FEDERAL TRADE COMMISSION**16 CFR Part 305****RIN 3084-AB15****Energy Labeling Rule****AGENCY:** Federal Trade Commission (“FTC” or “Commission”).**ACTION:** Final rule.

SUMMARY: The Commission issues final amendments to improve access to energy labels online and improve labels for refrigerators, ceiling fans, central air conditioners, and water heaters. The Commission is issuing these amendments to assist consumers in their purchasing decisions and ensure labels are consistent with Department of Energy requirements.

Sample Label 7 – Split-system Central Air Conditioner

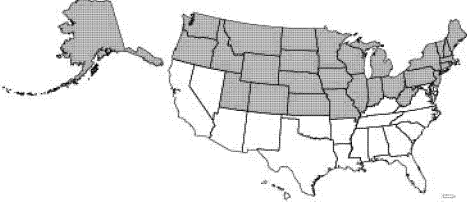
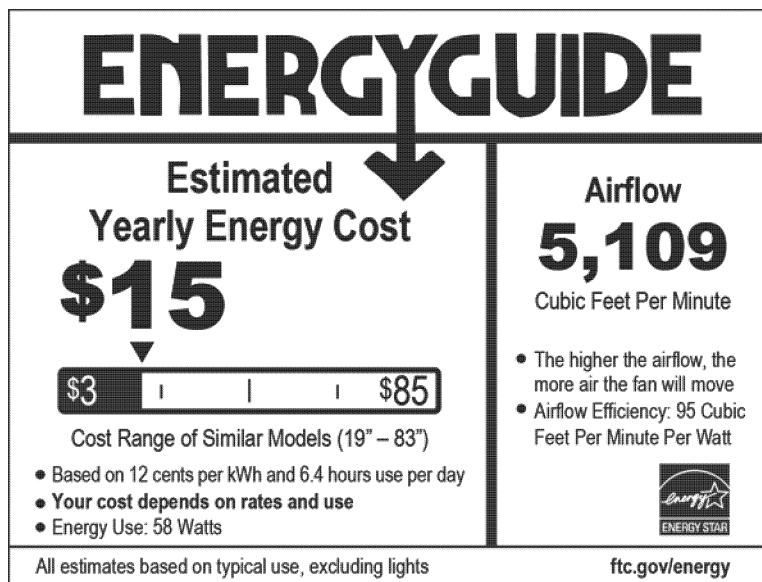
Comments: Regional Standards Information: The commenters generally supported the proposed revisions to the central air conditioner labels. AHRI explained that the state-specific information on the bottom of the proposed label is needed to clarify where a specific model may be sold. The Joint Commenters and the California IOUs emphasized that the label provides an important regional standards compliance tool. They also explained that the proposed changes accurately reflect the consensus recommendations of the DOE working group (Appliance Standards and Rulemaking Federal Advisory Committee (ASRAC)) convened to negotiate compliance and enforcement implementation for those standards.⁵¹ However, in addition to generally supporting the proposed label, the commenters raised several specific issues related to the proposal, including concerns about the SEER ratings for models, comparability ranges for the label, and the timing of the revised label. We discuss these comments below.

While the commenters generally supported the proposal, they disagreed on how the label should present a model's specific SEER rating. Industry members opposed the proposal to eliminate the model-specific SEER and EER ranges ("mini-ranges") for split-system air conditioners. For example, Goodman explained that this current information, which the Commission only recently added to the label, is essential to fully inform consumers about the range of available efficiencies. In Goodman and AHRI's view, the proposed single rating approach, which depicts the lowest efficiency rating of all certified coil-condenser combinations for the unit, would mislead some consumers who purchase systems with much higher ratings. AHRI further contended that the model-specific range

Discussion: Regional Standards Label for Central Air Conditioners. The Commission issues the final labels as proposed, including the three proposed label categories related to regional standards, but without the "mini-range" for split-system units.⁵³ In addition, as suggested by AHRI, the final central air conditioner label has a different SEER range for products that qualify for different regions. Specifically, for products that can be sold only in northern states, the low end of the range is 13 SEER. For other products, the low end is 14 SEER. This change will minimize confusion by eliminating comparative information related to models that may not be available for sale in certain regions due to the DOE standards. The Rule requires manufacturers to begin using the revised label nine months after the Commission publishes the amendments.

Energy Efficiency Ratio (EER): The installed system's minimum EER is 12.7.
